ATTACHMENT 2

WestConnex Stage 3 (M4-M5 Link) Concept Design Review Submission Facilitated by Beca Australia for Inner West Council July 2017

Attachment 1: WestConnex M4 – M5 Concept Design Plan Review – STRATEGIC ISSUES

Figure 2.6 Haberfield/Ashfield road connections (Source: M4 – M5 Link Concept Design Plan – May 2017)

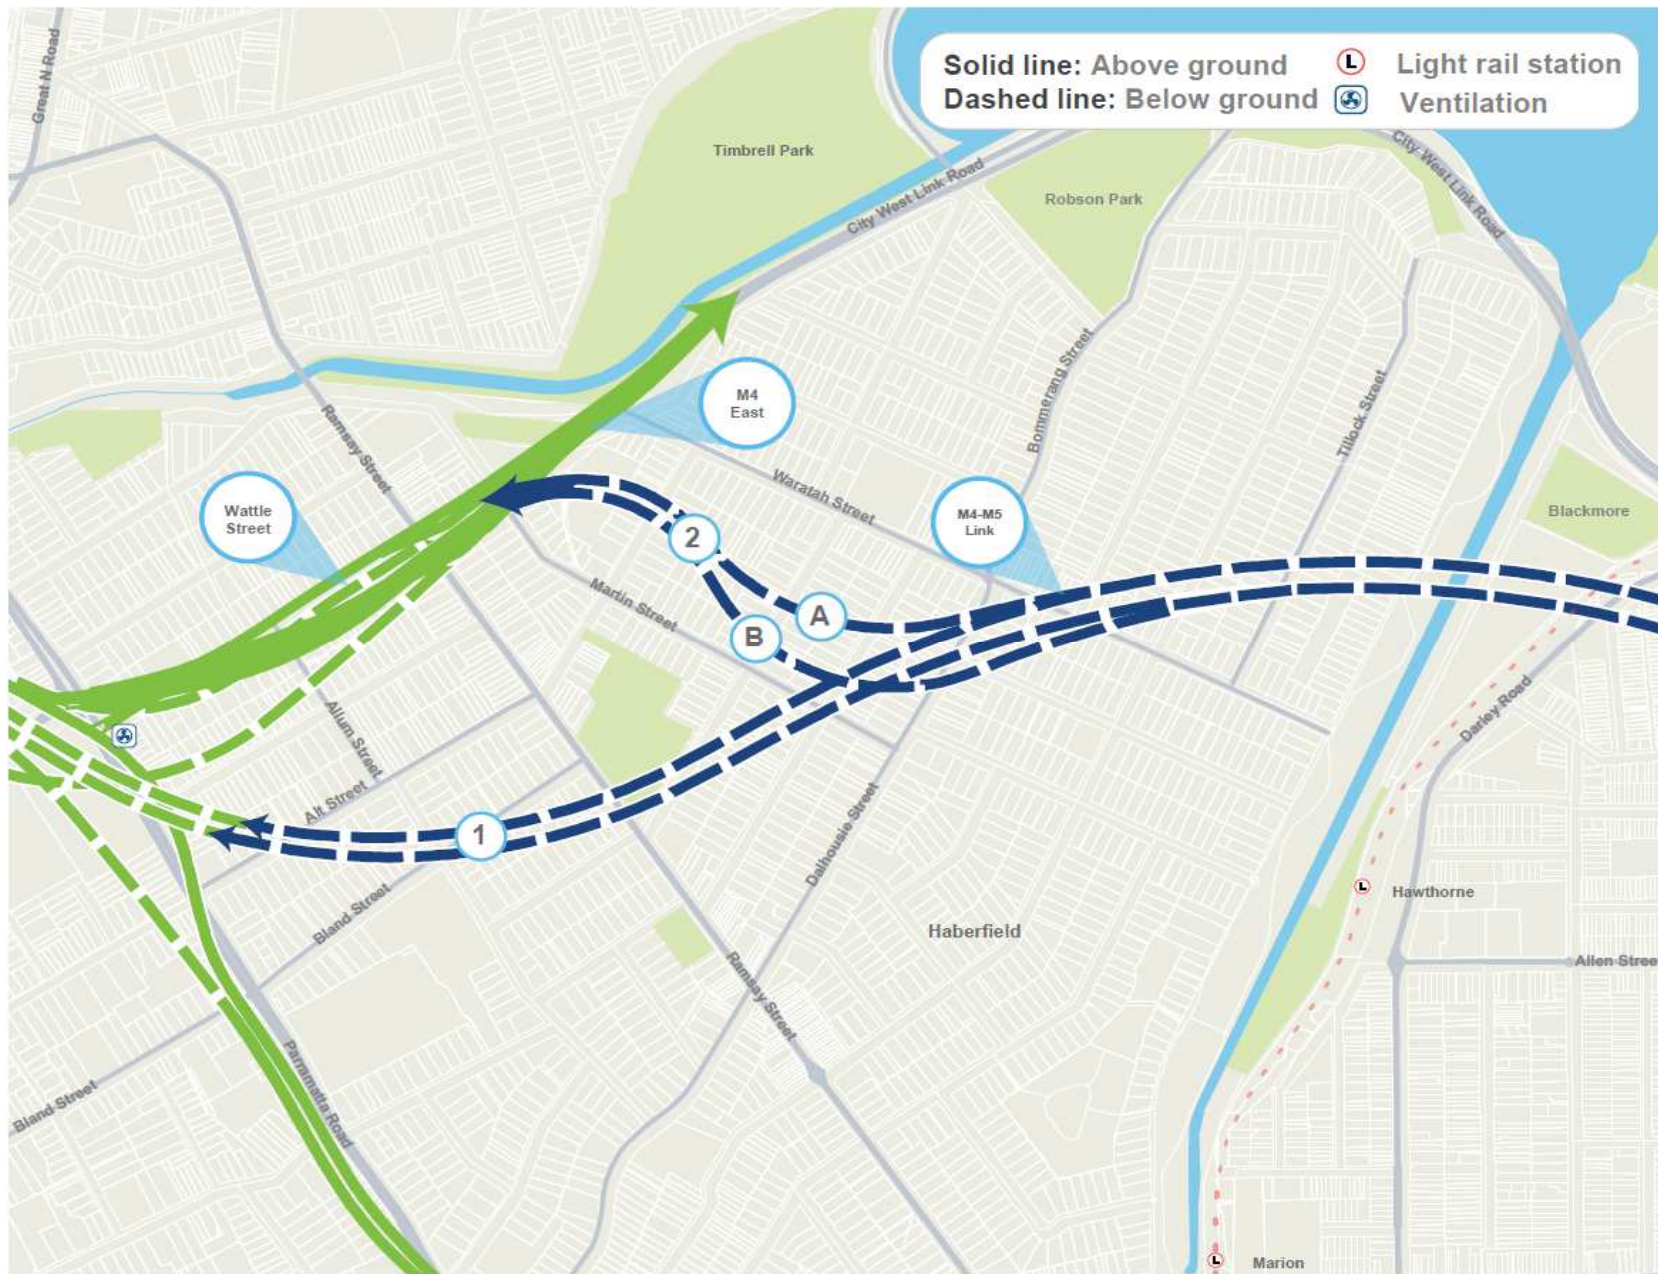
Item	Background information and source	Review comment
2	Traffic and Transport (construction and operation) – Cont.	
2.25	<p data-bbox="145 199 1095 287">M4 – M5 Concept Plan - Section 8 The M4 – M5 Link (page 20): M4 – M5 Link by Location Haberfield/Ashfield – Cont.</p> <p data-bbox="145 323 295 347"><u>Construction</u></p> <p data-bbox="145 368 1077 488">The construction sites being used for the New M4 project at Wattle Street and Walker Avenue, Haberfield (refer to Figure 2.7) will be needed while the two tunnels are integrated and these sites as well as Northcote Street may be used for other low intensity activities such as car parking and amenities.</p> <p data-bbox="145 525 1068 644">The use of these sites for the M4-M5 Link is subject to planning approval through the EIS process. During construction of the M4-M5 Link, we anticipate that the traffic, pedestrian and cycling arrangements around these sites will be similar to those currently in place.</p> <p data-bbox="145 681 1095 857">The New M4 project has been designed to enable the connection to M4-M5 Link. This means that surface works such as the realignment of Wattle Street will be undertaken as part of the New M4 project. M4-M5 Link will then connect into the realigned Wattle Street for the on and off ramps to the tunnel. The ventilation facility for the New M4 has also been designed to accommodate the needs of the M4-M5 Link.</p> <p data-bbox="145 893 338 917"><u>We are listening</u></p> <p data-bbox="145 938 1095 1026">In response to community feedback, the New M4 team is investigating options to return residual land to the community, subject to Roads and Maritime determination to release the land.</p> <p data-bbox="145 1046 1095 1106">Community feedback will be incorporated in an updated UDLP to be published in the coming weeks.</p>	<p data-bbox="1126 215 2134 300">A separate Construction Pedestrian and Traffic Management Plan (CPTMP) needs to be prepared in line with the proposed works associated with each proposed construction site. This should include:</p> <ul data-bbox="1149 320 2134 687" style="list-style-type: none"> ▪ Location of the proposed work zone; ▪ Haulage routes; ▪ Construction vehicle access arrangements; ▪ Construction program; ▪ Consultation strategy for liaison with surrounding stakeholders; ▪ Any potential impacts to general traffic, cyclists, pedestrians and bus services within the vicinity of the site from construction vehicles during the construction of the proposed works; ▪ Mitigation measures. Should any impacts be identified, the duration of the impacts and measures proposed to mitigate any associated general traffic, public transport, pedestrian and cyclist impacts should be clearly identified and included in the CPTMP. <p data-bbox="1126 719 2074 778">Details of the end-of-project plans for the site in terms of amenity, use and visual impact should be included in the EIS.</p> <p data-bbox="1126 810 2018 898">IWC understands the EIS will be ready for exhibition in late August or early September 2017, and expects the above information to be comprehensively addressed in the EIS.</p>

Figure 2.9 Rozelle Rail Yards construction site (Source: M4 – M5 Link Concept Design Plan – May 2017)

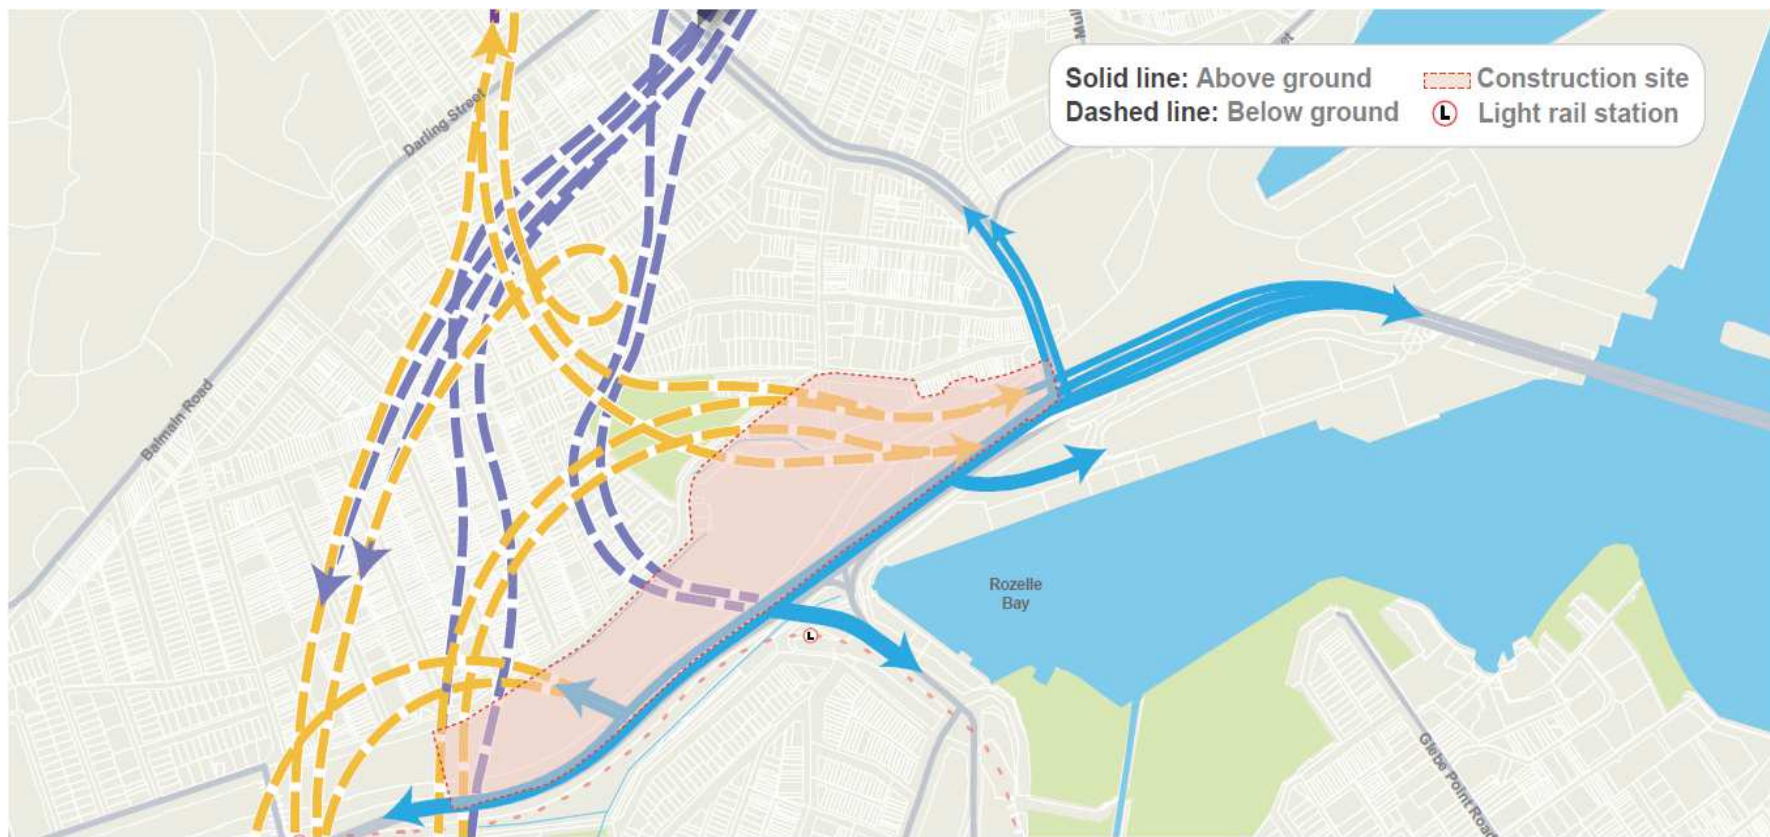
Item	Background information and source	Review comment
2	Traffic and Transport (construction and operation) – Cont.	
2.28	<p>M4 – M5 Concept Plan - Section 8 The M4 – M5 Link (page 42): M4 – M5 Link by Location</p> <p>Rozelle Rail Yards and Lilyfield – Cont.</p> <p><u>Constructions</u> The Rozelle Rail Yards will be used as the main construction site for the M4-M5 Link (refer to Figure 2.9). Construction activities will include launching the tunnelling machines, stockpiling and removal of extracted material, workforce car parking, offices and amenities, as well as infrastructure required to support the construction of the tunnels such as sedimentation ponds</p> <p>We are looking at options to move all heavy construction traffic directly onto City West Link. The final heavy vehicle movement routes will be detailed in the Environmental Impact Statement (EIS), which will be released for public consultation in mid-2017.</p> <p>Construction at the Rozelle Rail Yards site will run from 2018 to 2023. If the project is approved, tunnelling activities would be 24 hours a day, seven days a week and work would largely be underground or within acoustic sheds where they are at surface. Truck movements would occur 24 hours a day, seven days a week.</p> <div style="display: flex; justify-content: space-between;"> <div style="width: 45%; background-color: #f4a460; padding: 5px;"> <p>The M4-M5 Link provides an opportunity to improve the local environment within and surrounding the Rozelle Rail Yards.</p> <p>Key opportunities include:</p> <ul style="list-style-type: none"> pedestrian, cycling routes and the foreshore walk from Annandale, Glebe and Rozelle Bay, are largely blocked at the intersections of The Crescent, City West Link, Victoria Road and ANZAC Bridge and there is an opportunity to enhance connections, through the site, to the surrounding areas </div> <div style="width: 45%; background-color: #f4a460; padding: 5px;"> <ul style="list-style-type: none"> elements of the former use of the Rozelle Rail Yards including gantries and one light tower will be reused as they are an important reminder of the recent history of the site the major open green spaces of Easton Park and Bicentennial Park are currently isolated from each other. We plan to link them through new open space and active transport routes. </div> </div>	<p>A separate Construction Pedestrian and Traffic Management Plan (CPTMP) needs to be prepared in line with the proposed works associated with each proposed construction site. This should include:</p> <ul style="list-style-type: none"> Location of the proposed work zone; Haulage routes; Construction vehicle access arrangements; Construction program; Consultation strategy for liaison with surrounding stakeholders; Any potential impacts to general traffic, cyclists, pedestrians and bus services within the vicinity of the site from construction vehicles during the construction of the proposed works; Mitigation measures. Should any impacts be identified, the duration of the impacts and measures proposed to mitigate any associated general traffic, public transport, pedestrian and cyclist impacts should be clearly identified and included in the CPTMP. <p>Details of the end-of-project plans for the site in terms of amenity, use and visual impact should be included in the EIS.</p> <p>IWC understands the EIS will be ready for exhibition in late August or early September 2017 and expects the above information to be comprehensively addressed in the EIS.</p>

Figure 2.12 Roxelle Interchange - Victoria Road and other streets near the Iron Cove Bridge (Source: M4 – M5 Link Concept Design Plan – May 2017)

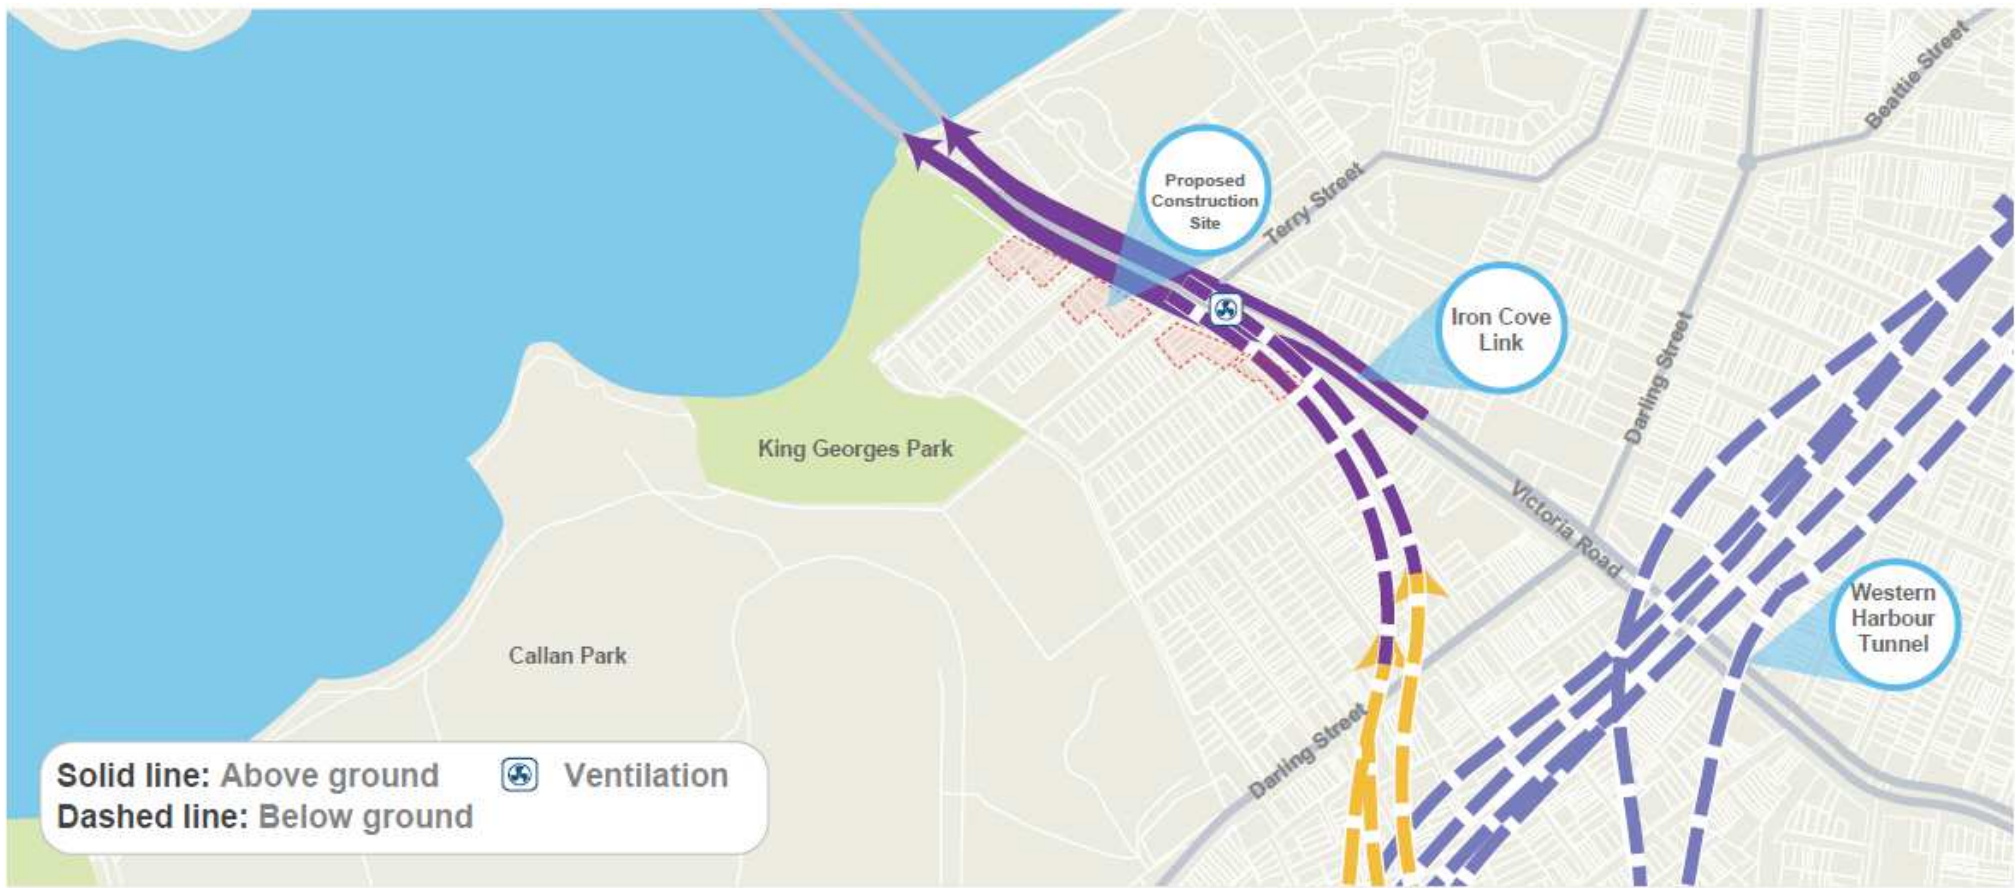
Item	Background information and source	Review comment
2	Traffic and Transport (construction and operation) – Cont.	
2.31	<p>M4 – M5 Concept Plan - Section 13 The M4 – M5 Link (page 50): M4 – M5 Link by Location, Rozelle</p> <p>Victoria Road and other streets near the Iron Cove Bridge – Cont.</p> <p><u>Road Connections</u> The road connections for the Iron Cove Link include entry and exit portals at the southern end of the Iron Cove Bridge. These will connect to the Rozelle Interchange in a two-lane configuration. The Iron Cove Link will provide an underground connection to and from the ANZAC Bridge, and to and from the New M5 via the main tunnels, as shown in Figure 2.12.</p> <p><u>Key opportunities for the area surrounding the proposed Iron Cove Link entry and exit include:</u></p> <ul style="list-style-type: none"> ▪ Iron Cove and the Bay Run are key destinations for locals and visitors to participate in cultural and recreational activities and there may be opportunities to create better pedestrian and cycle access; ▪ there is an opportunity to establish a green connection along Victoria Road, between Iron Cove and Rozelle Bay; ▪ there is an opportunity to establish a green connection along Victoria Road, between Iron Cove and Rozelle Bay; ▪ there are few marked and signalised crossings on Victoria Road and there may be an opportunity to improve the connection between either side of the road; and ▪ there is an opportunity to improve the streetscape along Victoria Road from Springside Street to the Iron Cove Bridge, particularly on the southern side, to encourage pedestrian activity in this area. <p>The Iron Cove Link surfaces on Victoria Road near the southern end of the Iron Cove Bridge. The road will be widened in this location to include the tunnel entry and exit portals. A number of properties will be acquired along the western side of Victoria Road to enable this road widening. All impacted property owners have been notified by Roads and Maritime Services.</p> <p>Preliminary traffic modelling suggests the Iron Cove Link will significantly reduce traffic on Victoria Road and provide an opportunity for revitalisation of the streetscape as well as improved active and public transport outcomes. As such, we have developed a concept design for Victoria Road from the Iron Cove Bridge to Springside Street.</p>	<p>The level of service for traffic entering and leaving a motorway on ramps can be a difficult attribute to determine. However, given the complexity of Rozelle Interchange and the potential for significant traffic impacts on densely-developed surrounding neighbourhoods, it is particularly important that this attribute is assessed comprehensively from concept through to implementation. It is expected that SMC will undertake this analysis through comprehensive modelling of all entry/exit ramps, junctions and streets to and from the interchange.</p> <p>IWC would like to view and understand these findings with areas of low expected levels of service highlighted in the EIS.</p> <p>It is IWC’s view that the proposed Iron Cove Link should be constructed between Iron Cove Bridge and the proposed subterranean junction in Rozelle Rail Yards and resultant spare capacity on Victoria Road should be used to provide enhanced public transport, active transport and public domain improvements. The opportunity should also be seized to use the benefits of less traffic on surface roads to invest in improving amenity on Parramatta Road and Victoria Road, in a way similar to King Street Gateway at St Peters. This should include the investigation of opportunities to reduce traffic flow and retain on-street parking to support local business.</p>

Figure 2.16 Acces problems to St George Park (Source: Leichardt Saints Football Club)

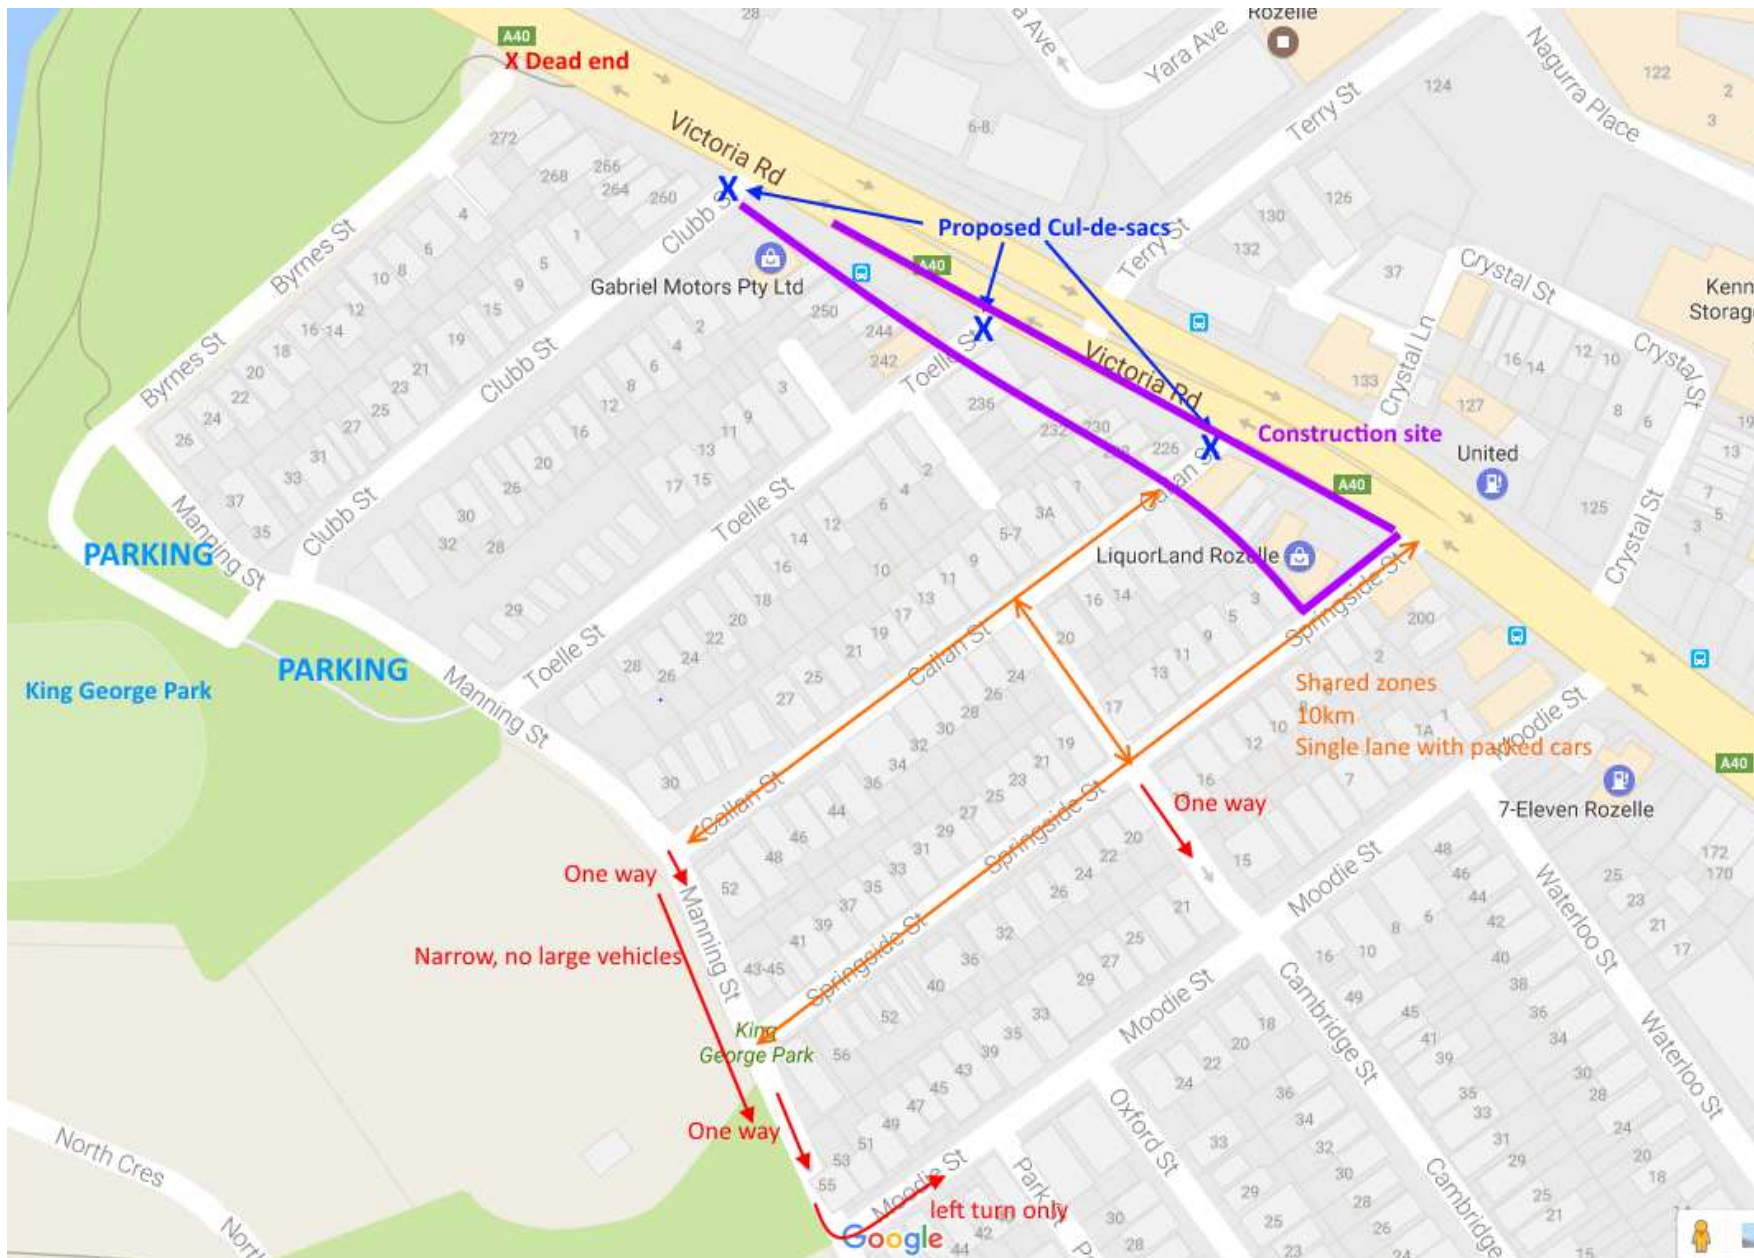
Item	Background information and source	Review comment
2	Traffic and Transport (construction and operation) – Cont.	
2.30	<p>M4 – M5 Concept Plan - Section 13 The M4 – M5 Link (page 48): M4 – M5 Link by Location, Rozelle</p> <p>Victoria Road and other streets near the Iron Cove Bridge</p> <p>Victoria Road will be widened near the Iron Cove Bridge to include tunnel entry and exit points for the Iron Cove Link.</p> <p>There would be a construction site on Victoria Road, between Springside Street and the Iron Cove Bridge. Following construction, there will be pockets of residual land remaining on Victoria Road between Springside Street and the Iron Cove Bridge.</p> <p>Sydney Motorway Corporation and Roads and Maritime Services are open to how this residual land could be used once construction is finished.</p> <p>We are keen to get feedback from the community and other stakeholders about how you would like to see this land used. Some options include children’s play spaces, passive open space, community gardens or outdoor gyms.</p> <p><u>Design features:</u></p> <ul style="list-style-type: none"> ▪ Tunnel exit and entry on Victoria Road near the Iron Cove Bridge; ▪ Trees and an improved streetscape along Victoria Road; ▪ The Iron Cove Link will be entirely underground; ▪ A ventilation facility between the northbound and southbound lanes of Victoria Road <p><u>Depth of tunnel at Annandale/Camperdown</u> - Tunnel depth is up to 35 metres below the surface (refer to Figure 13.2 of the Concept Plan)</p> <p><u>Construction dates</u> - Construction will run from 2018 to 2023 (pending approval).</p>	See Item 2.41 and Figure 2.16
